Access Compliance Report

Public Rights-of-Way (Curb Ramps)

Intersection ID: 2902	Main Street: FOREST_PATH_DR	Cross Street: GREEN_HEDGE_AV	Location: W
ADA ID: 20050E60416B	Ramp Type: Perp	Initial Pass/Fail: Fail	Overall Compliance: No
Severity Score: 12.5			
Codes/Mitigation Info/Possible Solution		Field Measurements/Component Compliance

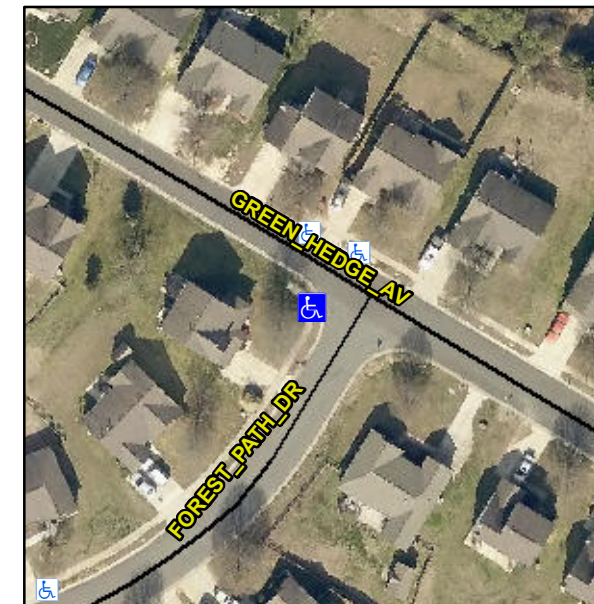
Not Found, R304.2.2

Compliance	Description	Data	Compliance	Description	Data
N/A	Ramp Length (in)	47.0	No	Ramp Slope (%)	11.6
Yes	Ramp Width (in)	48.0	Yes	Ramp XSlope (%)	0.8
N/A	Flare Type LT	N/A	N/A	Flare Type RT	N/A
N/A	Flare Slope LT (%)	N/A	N/A	Flare Slope RT (%)	N/A
N/A	Flare Traversable LT?	N/A	N/A	Flare Traversable RT?	N/A
N/A	Landing Length (in)	N/A	N/A	DWS Provided?	N/A
N/A	Landing Width (in)	N/A	N/A	DWS Contrast?	N/A
N/A	Landing Slope (%)	N/A	N/A	DWS Length (in)	N/A
N/A	Landing X Slope (%)	N/A	N/A	DWS Full Width?	N/A
N/A	Landing Curb? (Y/N)	N/A	N/A	DWS Offset (in)	N/A
N/A	Shared Landing?	N/A			
N/A	Gutter Ponding?	N/A	N/A	Gutter Slope (%)	N/A
N/A	Gutter Lip Ht (in)	N/A	N/A	Gutter X Slope (%)	N/A
N/A	Painted X Walk1?	No	N/A	Painted X Walk2?	N/A
	X Walk 1 Direction	To NE		X Walk 2 Direction	N/A
N/A	X Walk 1 Width (in)	N/A	N/A	X Walk 2 Width (in)	N/A
	X Walk 1 Slope (%)	2.1		X Walk 2 Slope (%)	N/A
	X Walk 1 X Slope (%)	0.3		X Walk 2 X Slope (%)	N/A

Remove & Replace Entire Ramp.
